Deadline 6 Submissions on the A66 Northern Trans-Pennine Project

Submitted on Behalf of Messrs Heron

2. Applicant's Response to Examining Authority's Request under Agenda Item 10 – Replacement Sites Considered for Brough Hill Fair Conclusion

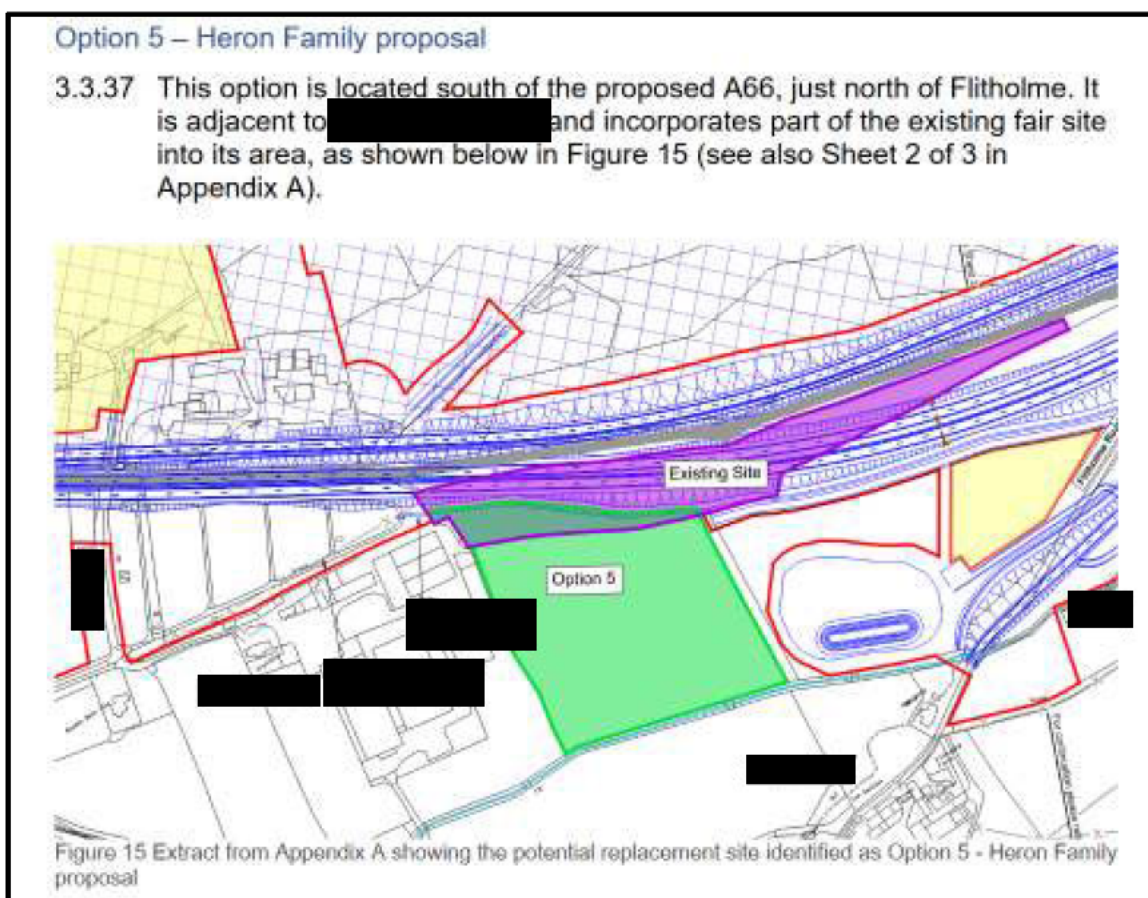
2.1 We have reviewed the above document submitted by the Applicant at Deadline 5¹, and make the following comments in relation to the Applicant's consideration of the site proposed by the Heron Family which is referred to as Option 5 and shown in the plan extract below:

2.2 The stated area for Option 5 (6.2 acres)² is incorrect because part of the existing Brough Hill location could be incorporated. We assess the total area of the fields to be in the region of 9.4 acres and it can therefore accommodate

the target area of 5.4 acres useable space. The relevant area is shown tinted red on the plan below:

2.3 We do not agree with the Applicant's assessment that there would be a useable acreage of 4.0 acres for Option 5, not only because part of the existing site can be incorporated (as it is for Option 1), but also because we submit a greater part of the site would be useable.

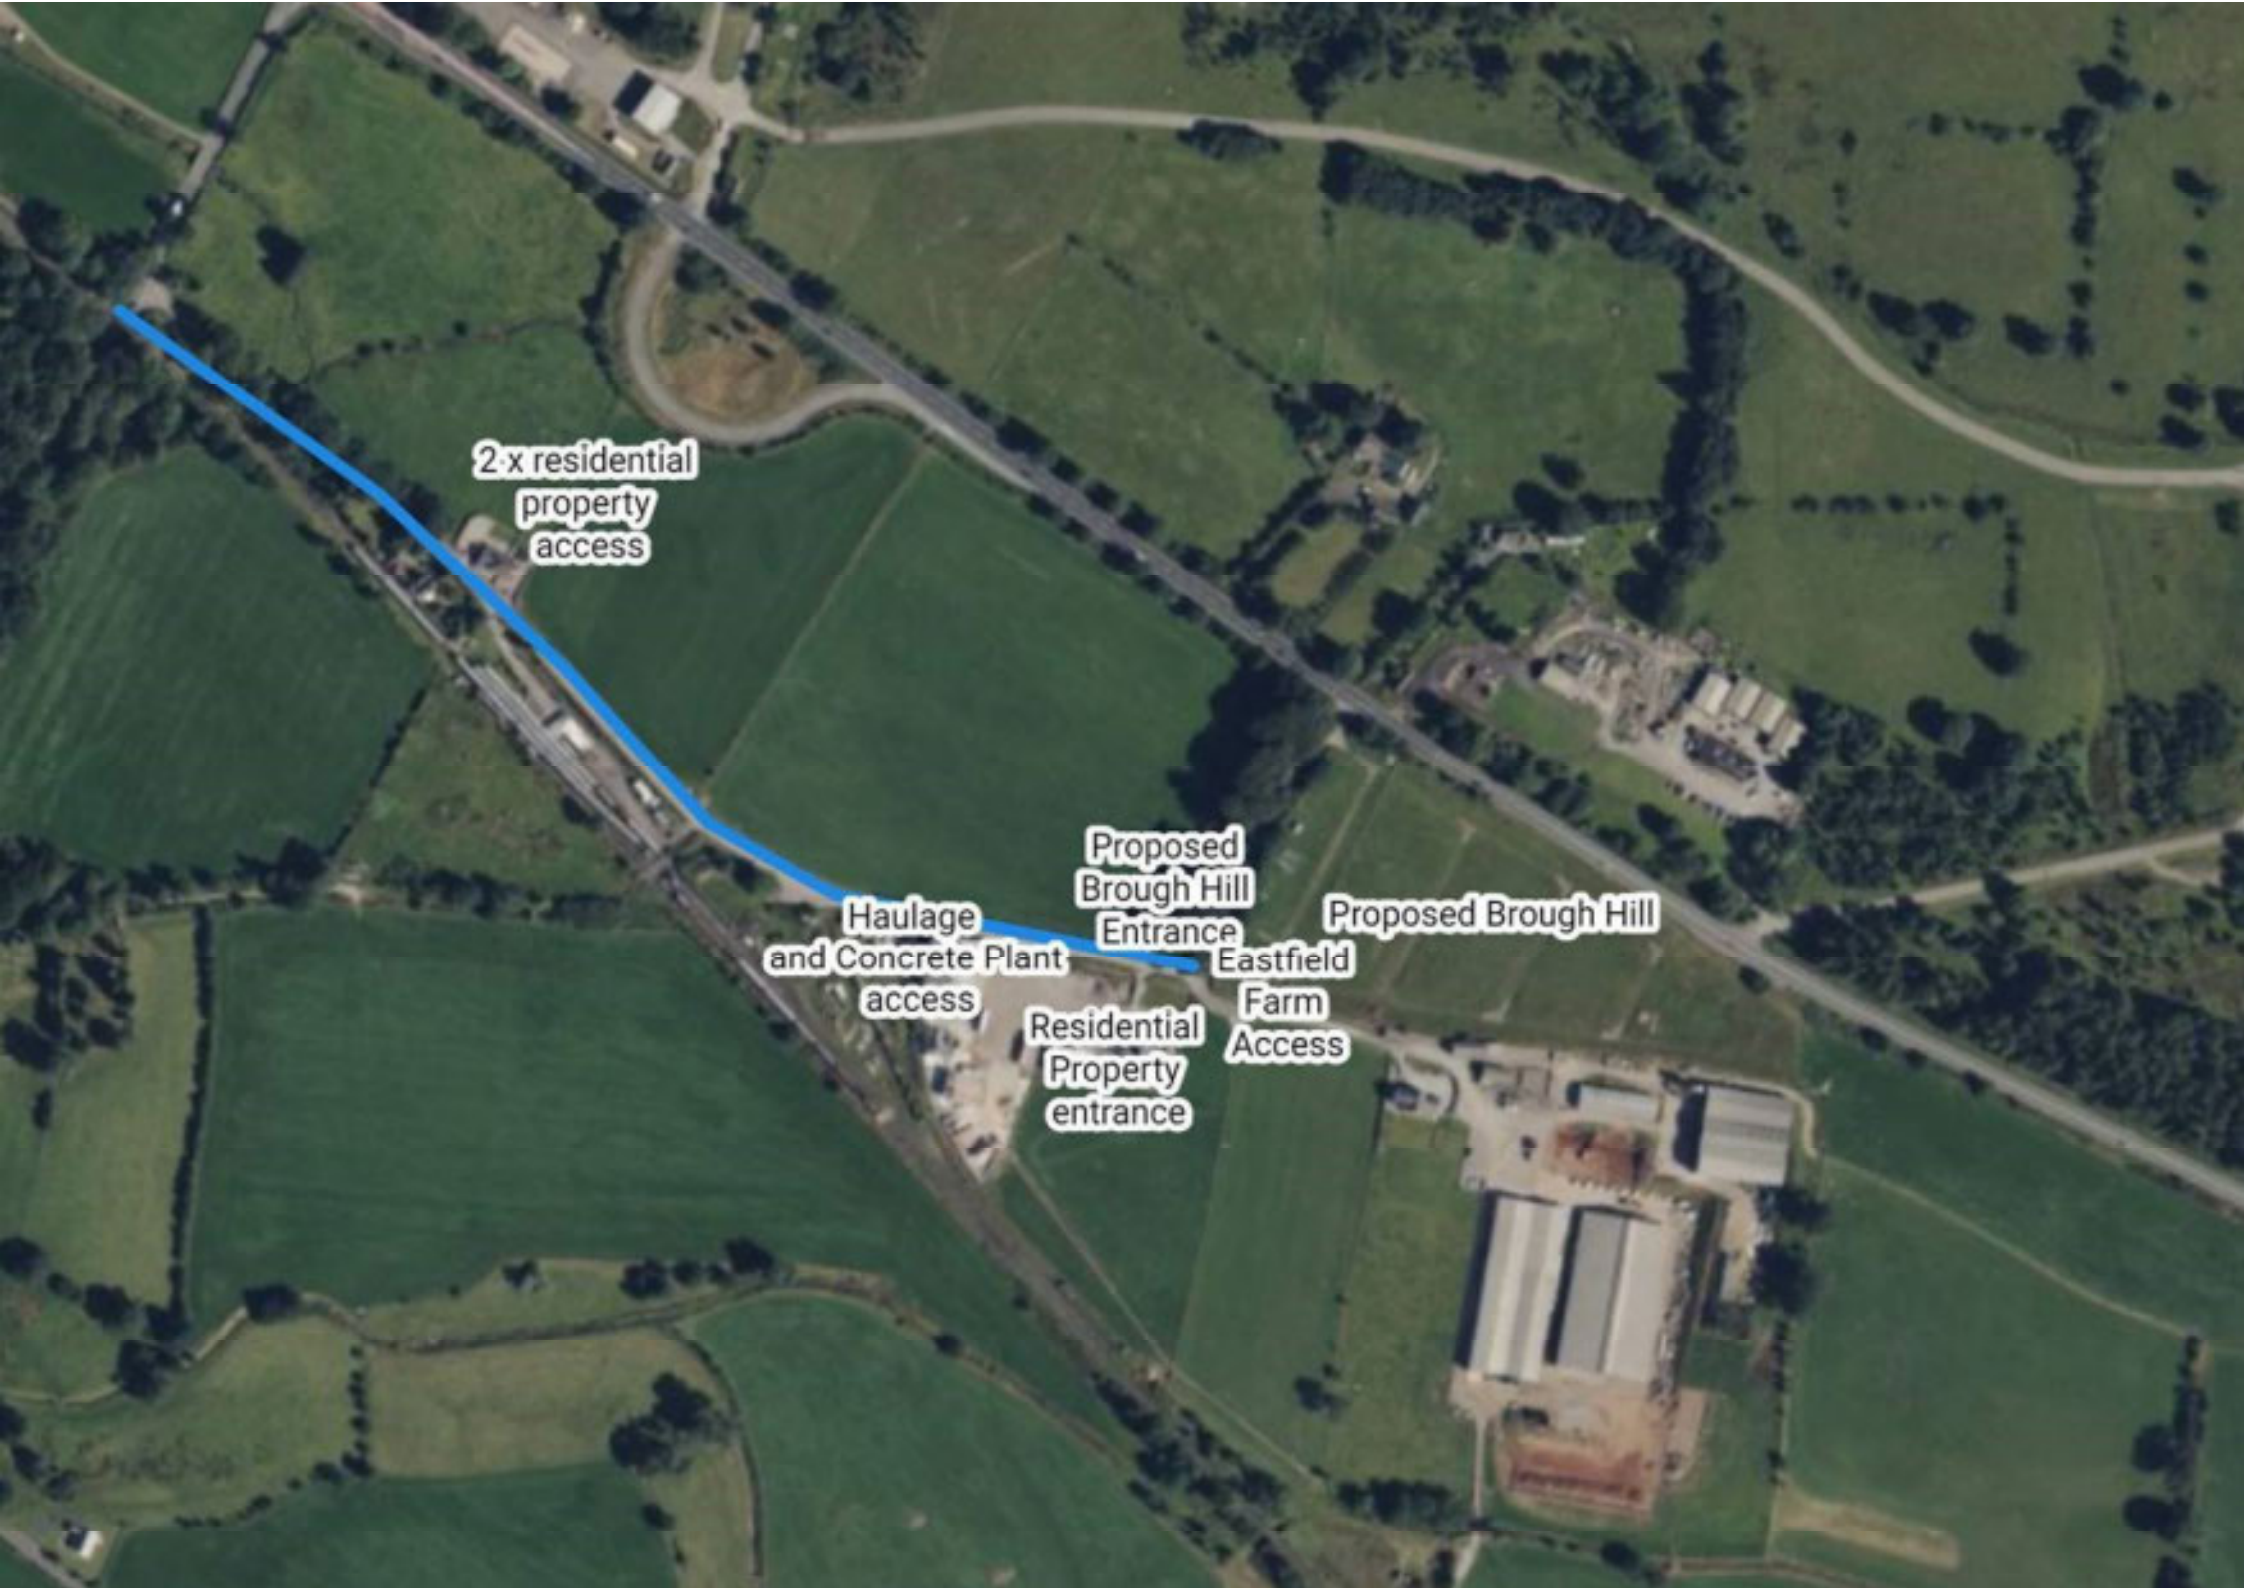
2.7 We also respectfully submit that the Applicant has erred in suggesting that a new access would be required for Option 5. The current plans submitted by the Applicant already show a private means of access for the Heron family from the east which could be used for entry and egress from the site avoiding the use of Station Road and therefore reducing the extent of health and safety concerns.

2.8 Figure 10 of the Applicant's submission³ does not show the proximity of the access to [REDACTED]. Whilst we appreciate that the ExA have visited the site, we feel it useful to include below an image similarly obtained from Google Streetview showing a slightly wider view for reference:
